Iowa DAS - DOC 4JD CBC New Central Office Building

Addendum #01

Dated: April 30, 2026

ADDENDUM NUMBER ONE
To Contract Documents for:
IOWA DAS – DOC 4JD CBC NEW CENTRAL OFFICE BUILDING
SVPA Project No. 25079
Owner Project No. 9488.00

2 LEVEL 2 - FLOOR FINISH PLAN
SCALE: 1/8" = 1'-0"1 LEVEL 1 - FINISH FLOOR PLAN
SCALE: 1/8" = 1'-0"

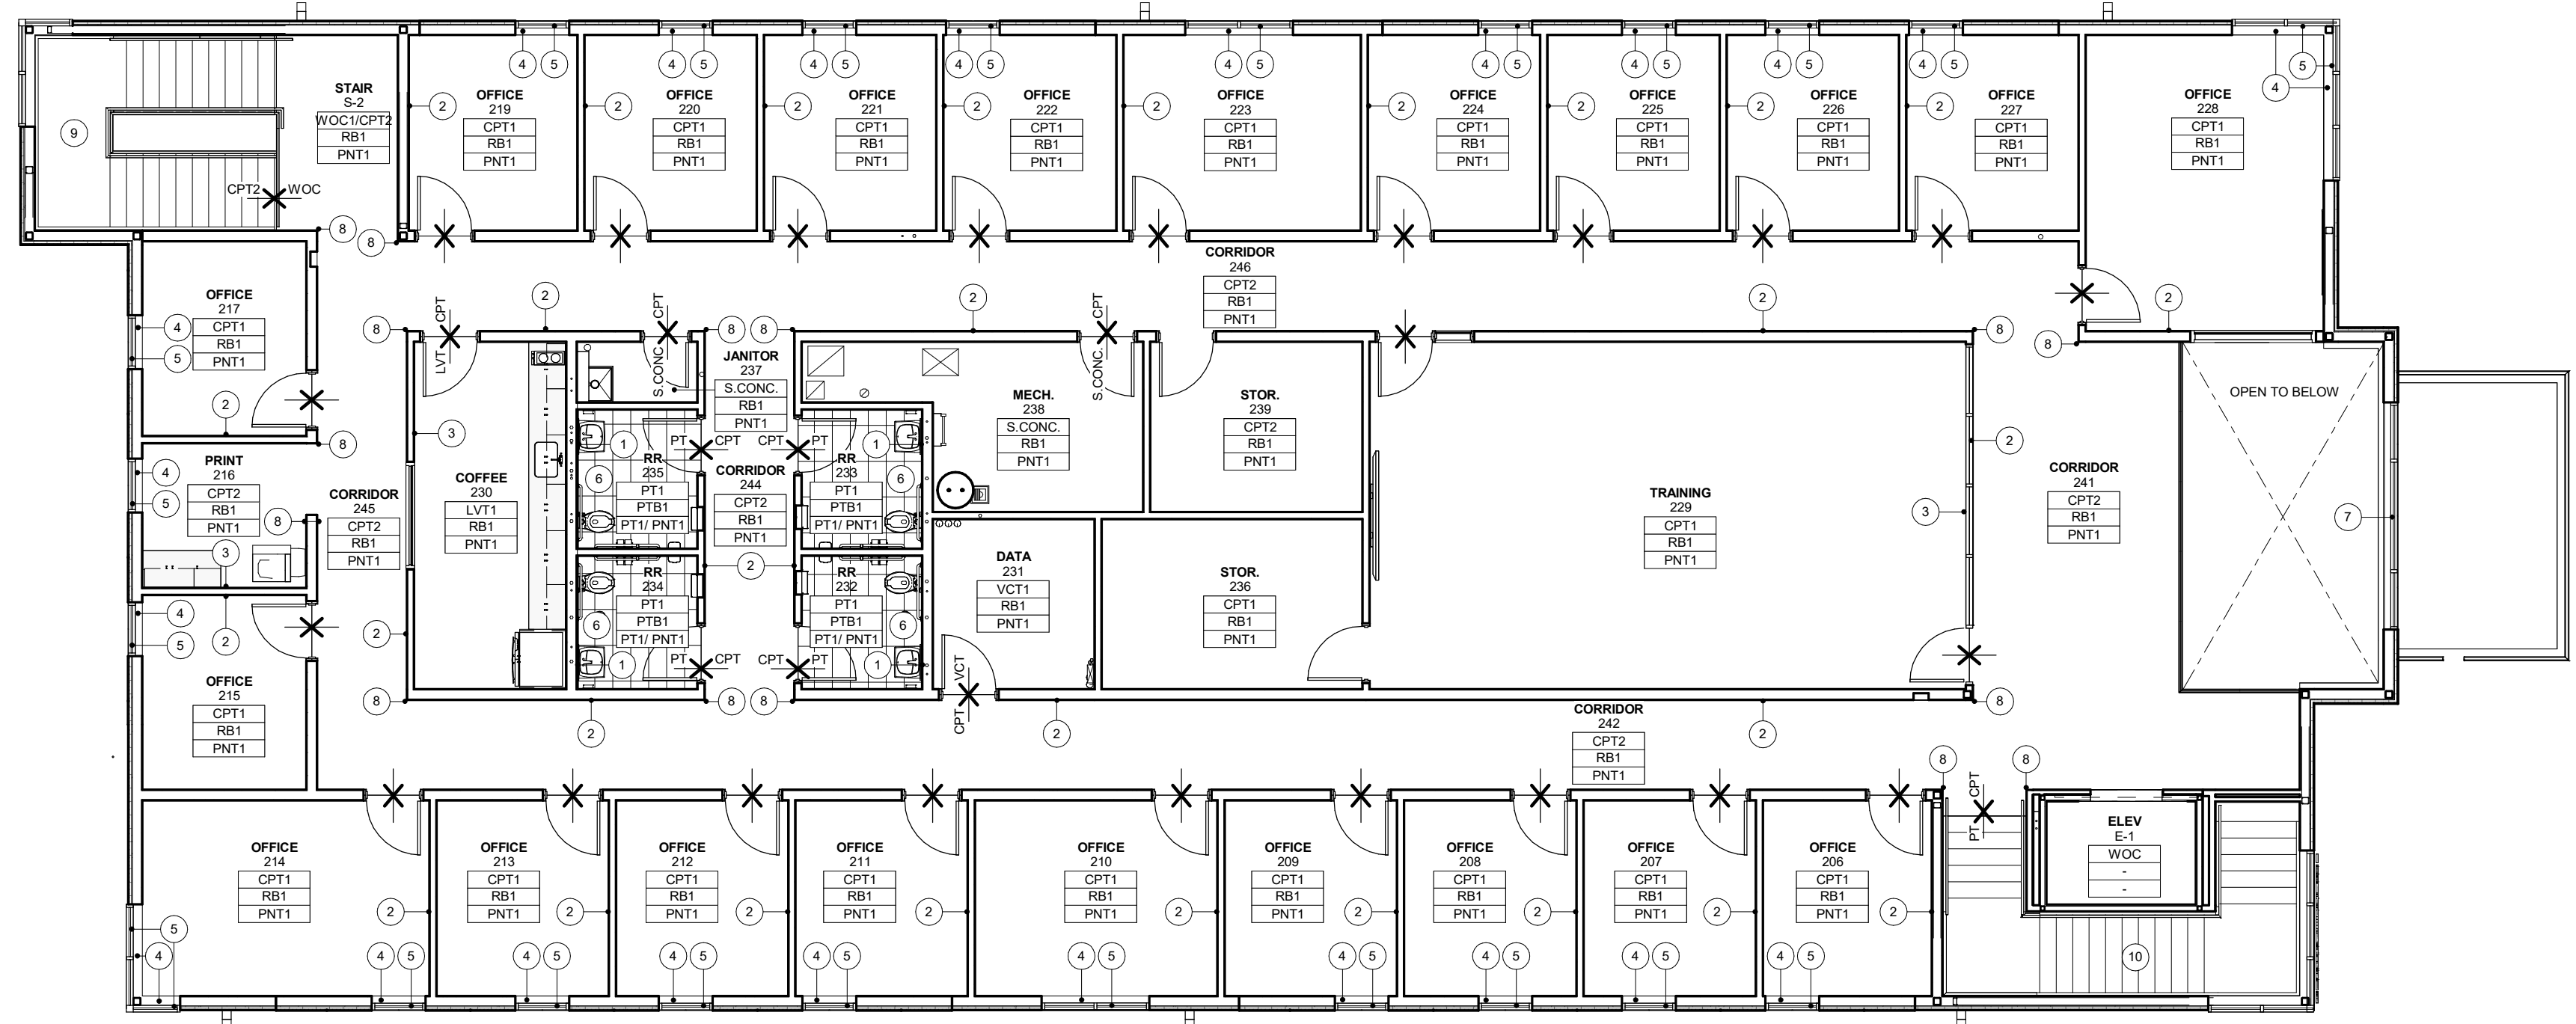
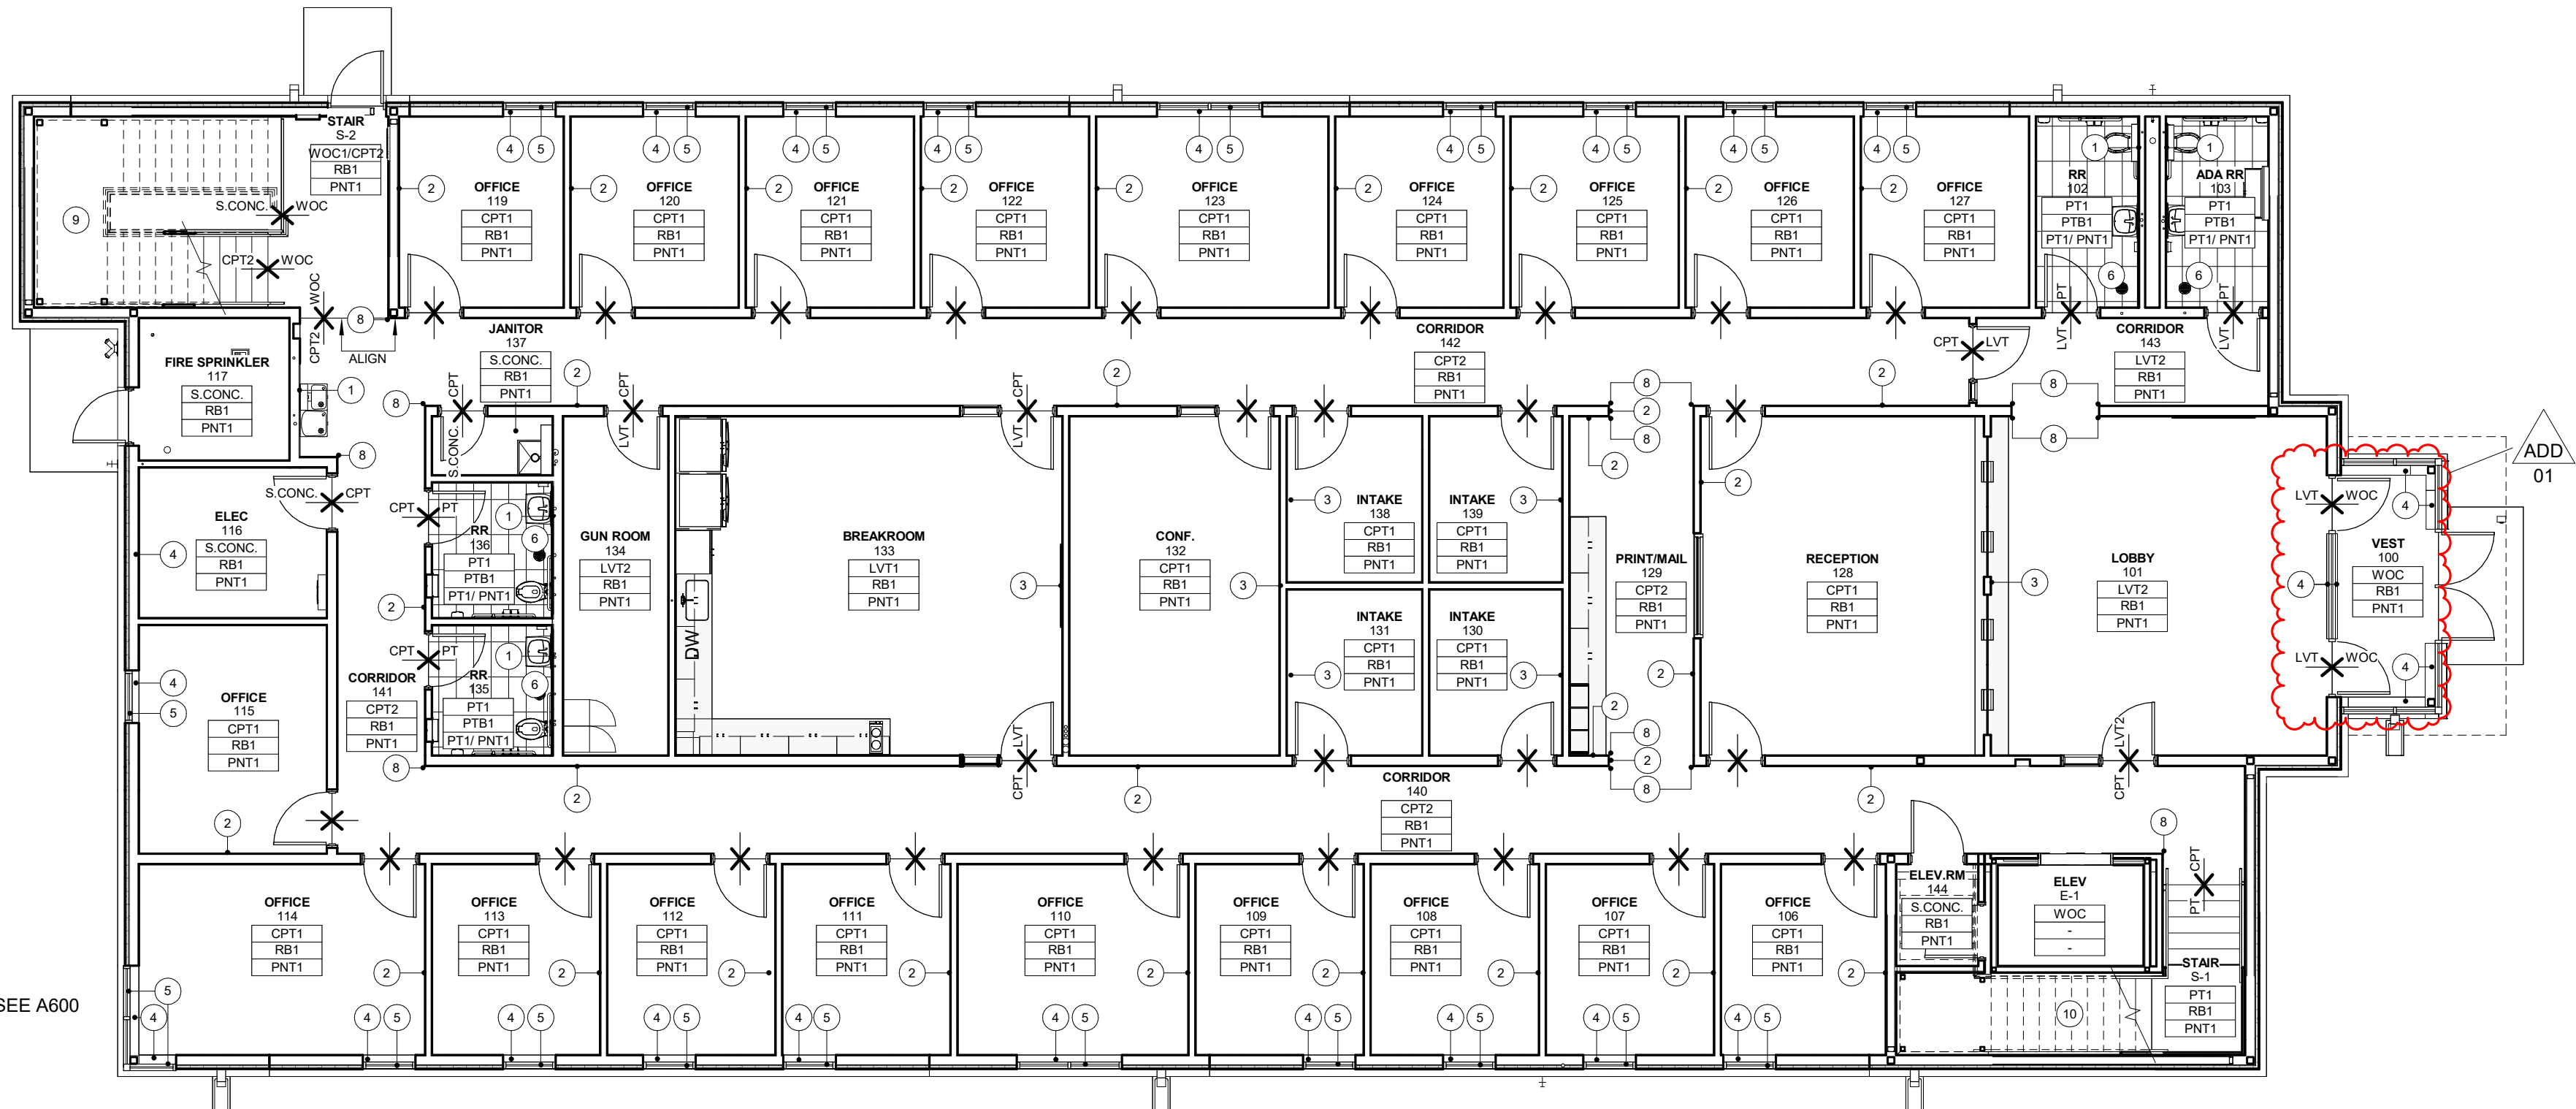
- A. ADD note 4 to windowsills at Vest 100.
- B. See attached revised sheet A800.

LEVEL 1 - HVAC PLAN

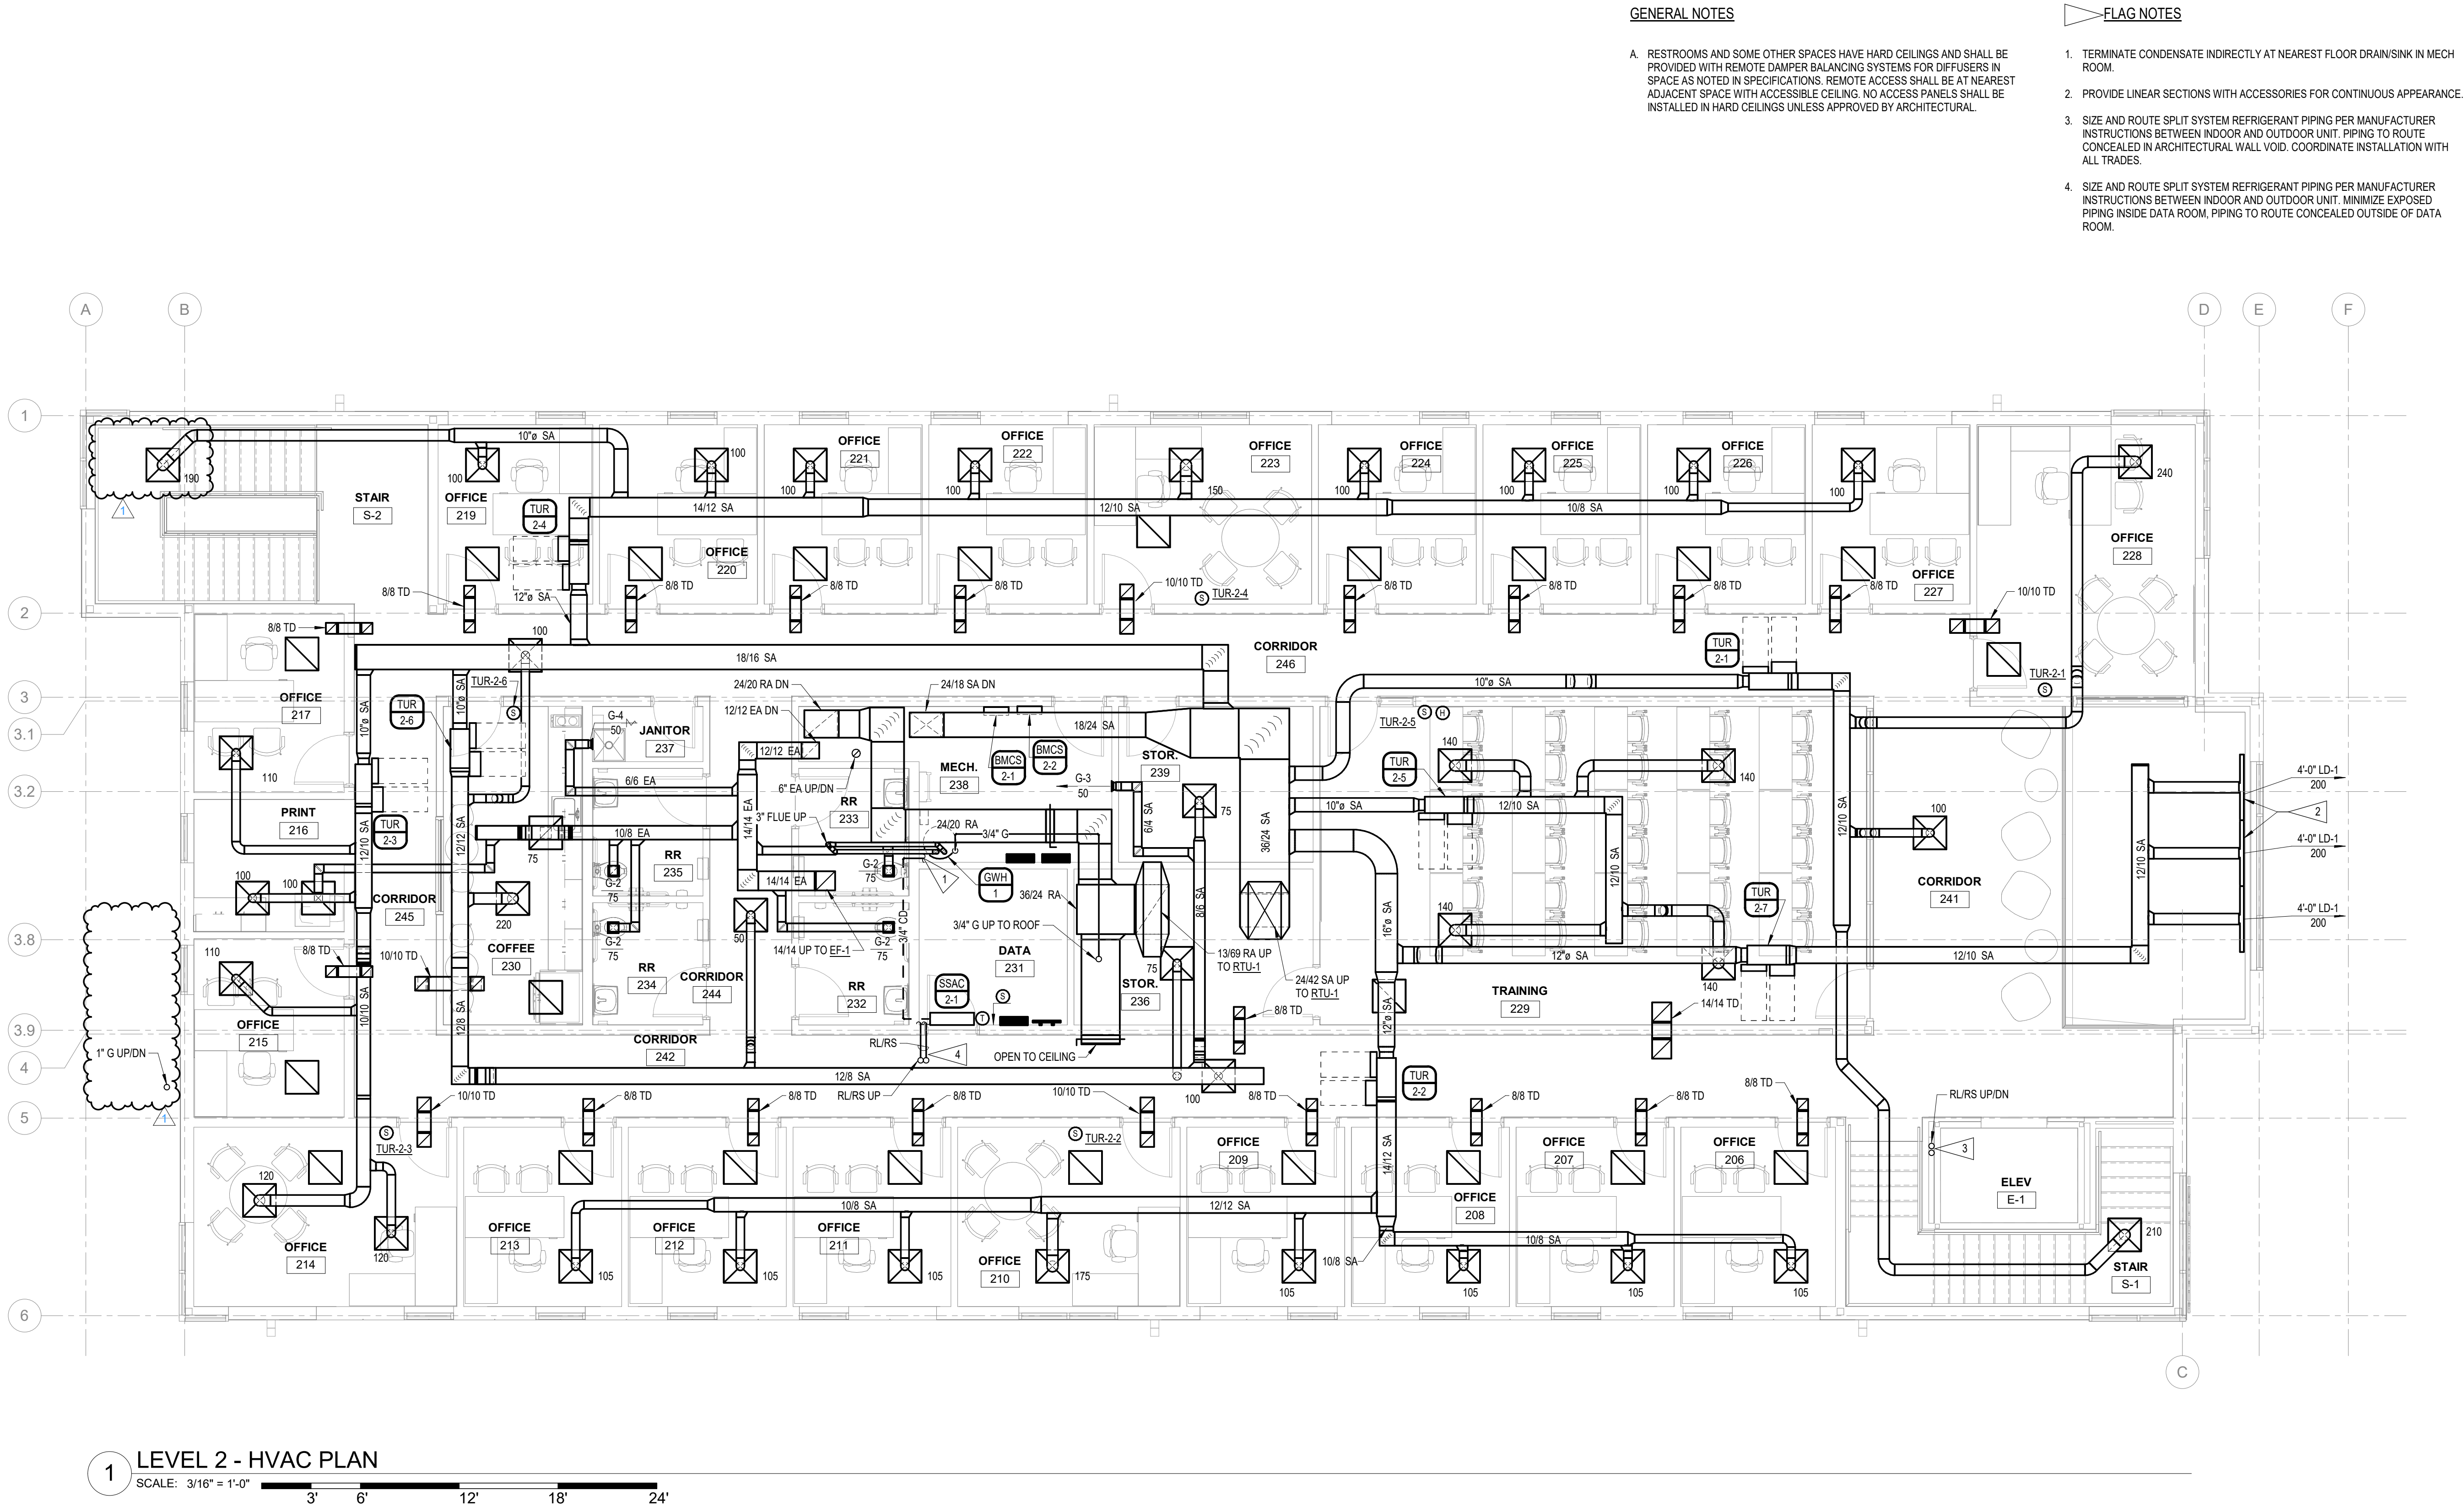
- A. REVISE diffusers and grilles in Office 115 and Breakroom 133.
- B. REVISE gas meter and gas pipe up location.
- C. See attached revised sheet M100.
